**MINUTES OF THE MEETING OF THE SUBDIVISION  
AND DEVELOPMENT APPEAL BOARD  
TUESDAY, MARCH 29, 2016 at 7:00 p.m.**

**3. Appeal of Development Application 16-DP-008  
Lot 13, Block 49, Plan 7361JK (99 - 6 Street SE, Redcliff)  
(Addition to existing detached garage)**

**Re: Appeal of Development Permit Application 16-DP-08**

Proposed By Applicant

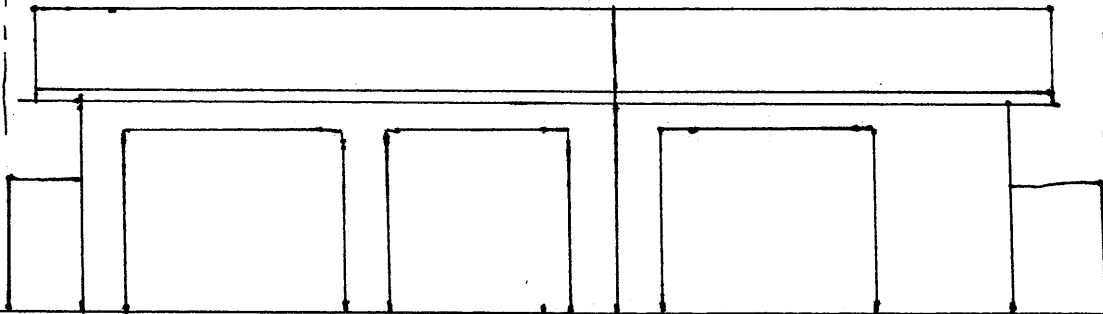
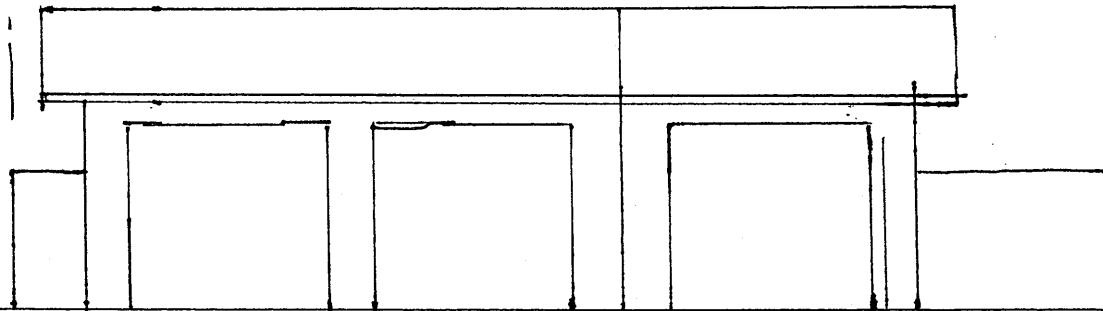
The applicant proposed construction of a 5.48 metre extension on the north side of their garage that accesses the Town's lane east of the property.

1. The proposed garage addition does not meet the following provisions of the LUB:

- Section 40.11 – *The maximum size of an accessory building(s) is limited to 15% of lot size or 92.9m<sup>2</sup> whichever is less, and*
- Section 40.13 – *No accessory building shall occupy more than two-thirds of the width of the rear yard of any lot or as required by the Development Authority.*

The proposed addition would also make the accessory building larger than the principle building.

Examining the LUB if the applicant had proposed a 4.12 metre addition of the same depth of the existing garage, to the garage, the Development Officer could have approved it.

Max to meet 15% Bylaw Requirement
